**PLAN COMMISSION MEETING
IN PERSON AND VIA ZOOM
TUESDAY, APRIL 9, 2024 – 4:00 PM
CITY HALL – SECOND FLOOR**

- a. Review and possible action relating to the minutes of the **March 12, 2024, regular Plan Commission meeting**
- b. Review and possible action relating to a **Site Plan Review for Opportunities Inc.**, for the property located at 201 East Cramer Street (SPR-2024-01) (Selle)
- c. Review and possible action relating to a **CSM for Opportunities Inc.**, for the property located at 201 East Cramer Street (CSM-2024-02)
- d. Review and possible action relating to a **Special Area Design Review-Signage for Paddy Shack**, for the property located at 201 South Main Street. (SADR-2024-03) (Selle)

SITE PLAN REPORT TO THE PLAN COMMISSION

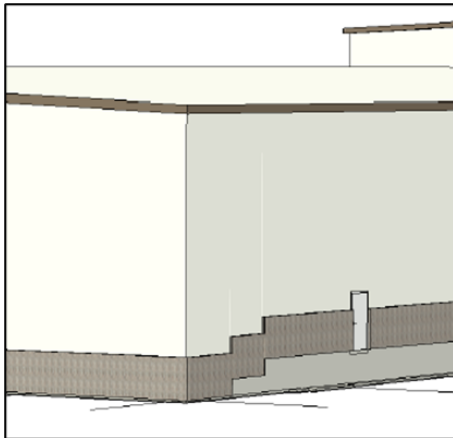
- 355 landscaping points are required for the street frontage = met (407 provided)
- 124 landscaping points are required for the paved surface areas = met (145 provided)
- 393 landscaping points are required for the building foundation = not met (349 provided)
- 536 landscaping points are required for the yards = met (550 provided)

The total proposed landscaping points equates to 1,451 points and a total of 1,422 points are required. If acceptable to the Plan Commission, the total landscaping points required have been met, even though the building foundation point totals are slightly short of the total required. To note, per Section 15.08.30(5)(b), there are no Bufferyard requirements along street frontages (Jefferson Street has existing neighborhoods to the east).

- Accept the landscaping plan as shown with the required total number of points being exceeded, even though the total building foundation landscaping points do not meet the minimum required.

A2.0

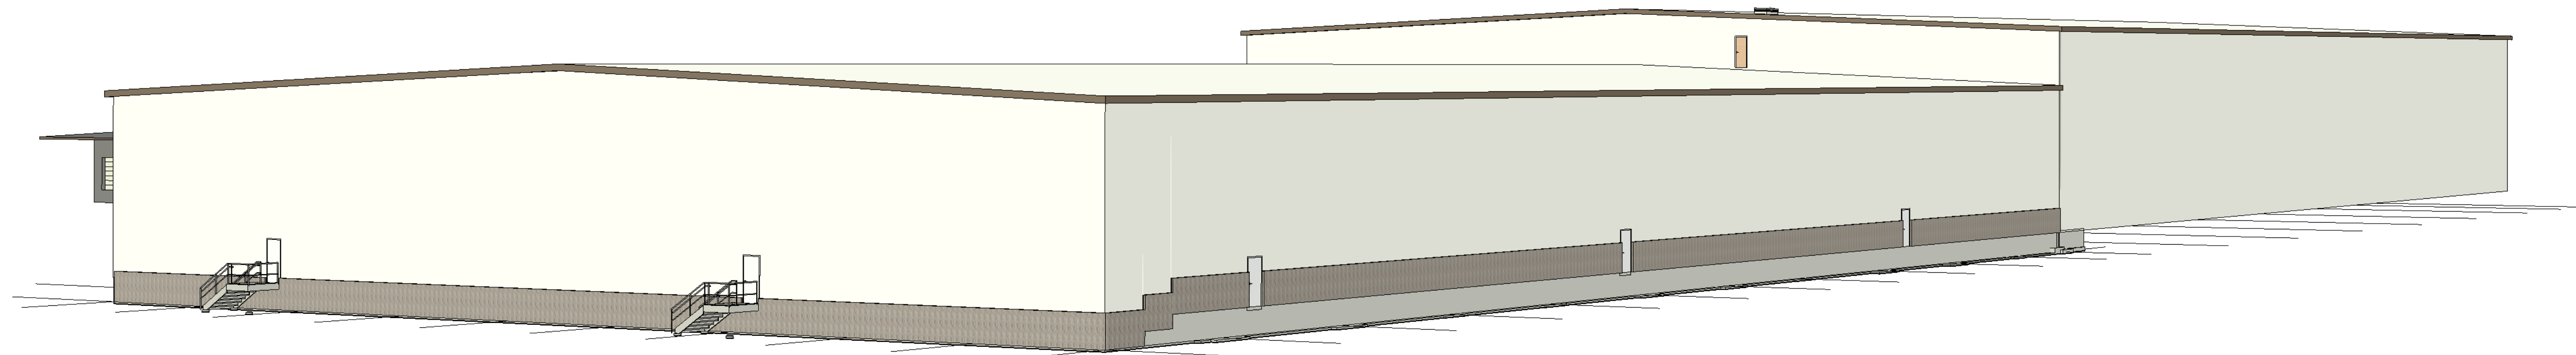
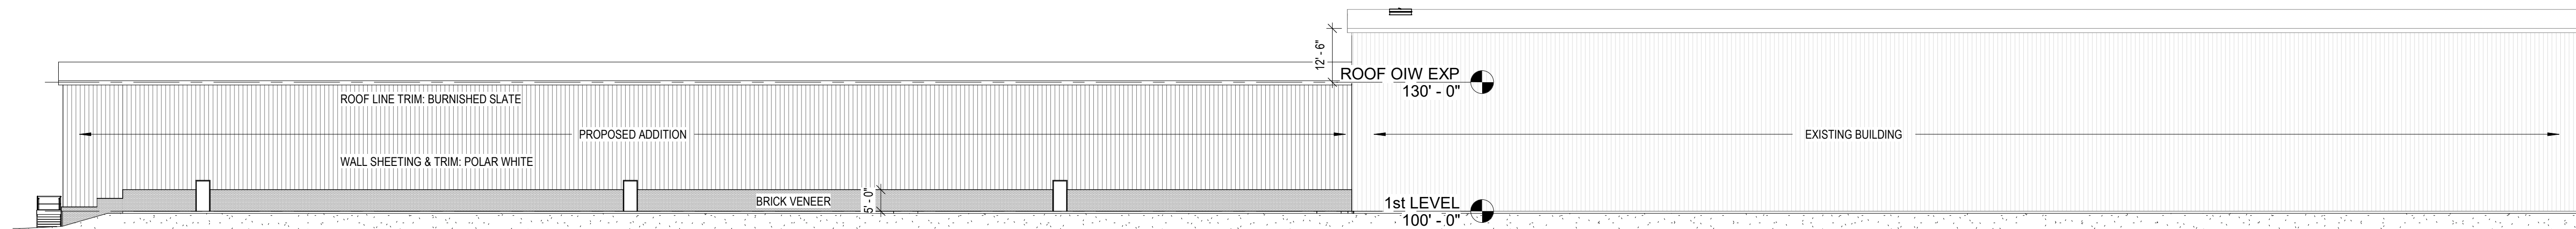
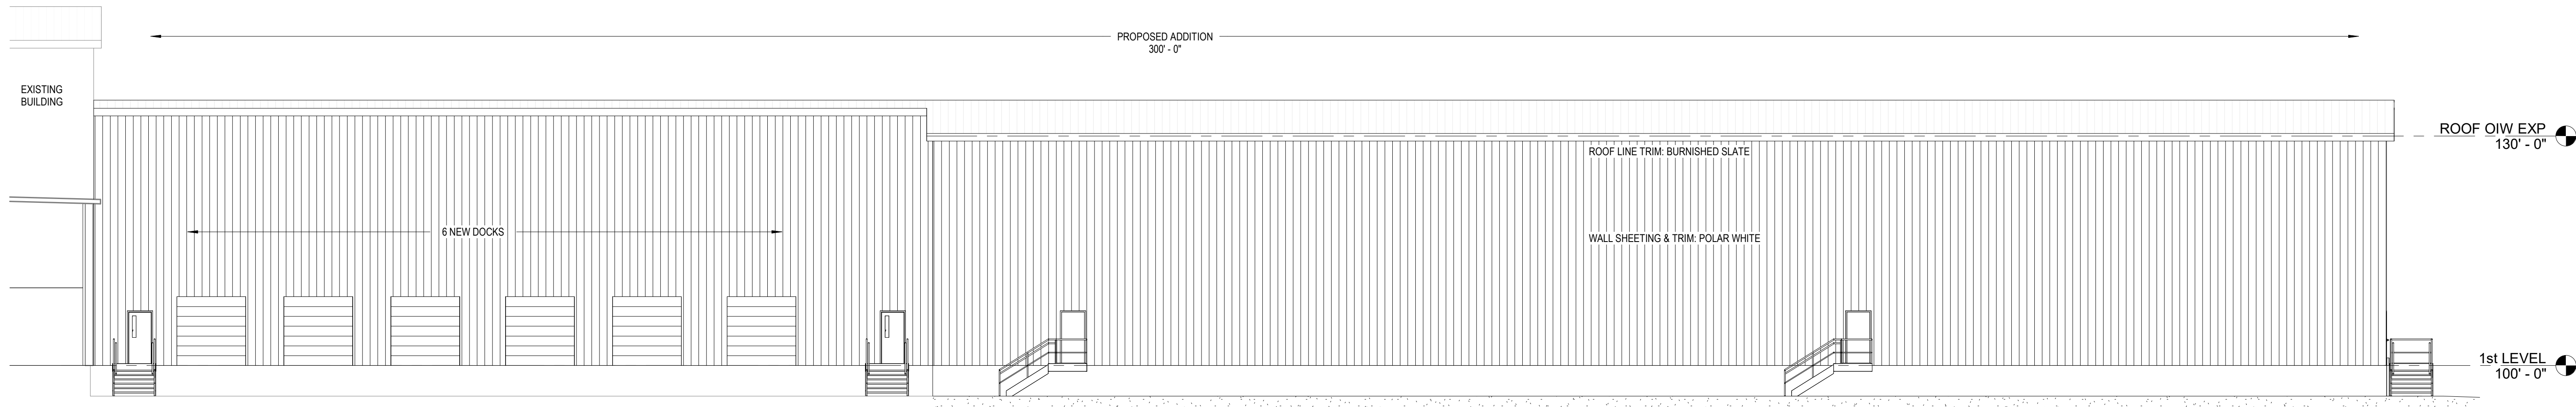
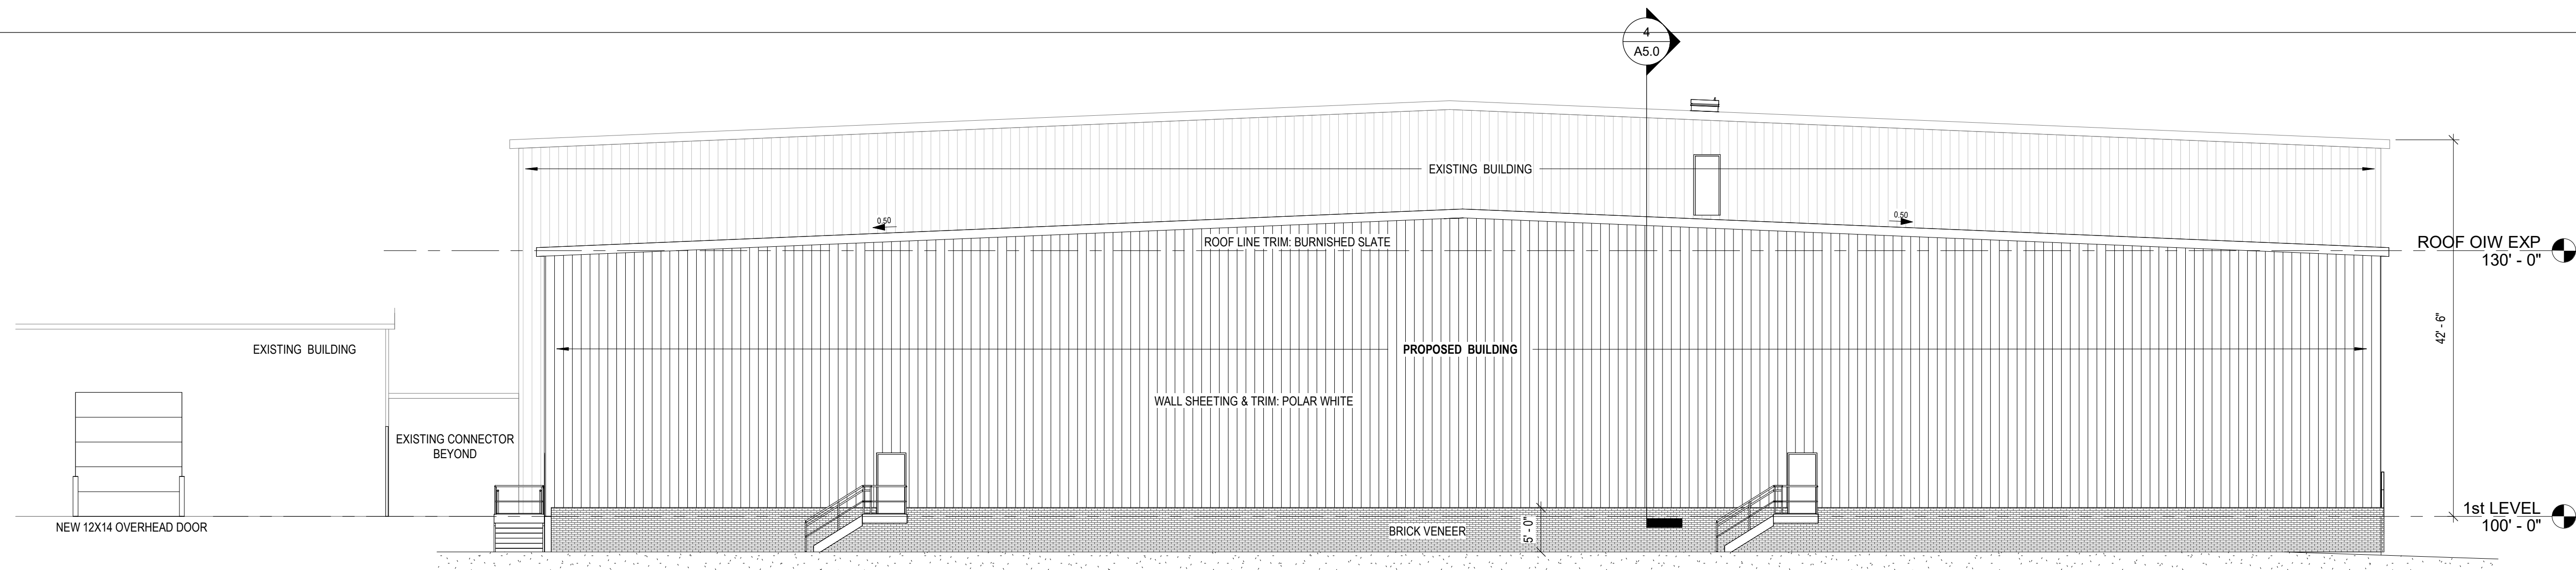
The brick veneer façade materials generally align with the foundational area on the east and south sides of the proposed building addition. The grade creates a situation where the east façade's brick materials are higher up the building than on the south side to align with the base elevation of the ground surrounding those sides of the building. The brick is wrapped around the southeast corner and adjusted via a step pattern on the east façade for the grade change. The Plan Commission should discuss this design approach.

- Plan Commission discussion and determination on the appropriate building material design around the southeast corner of the structure utilizing the brick veneer with the grade changes that occur between the south and east sides of the proposed building addition.
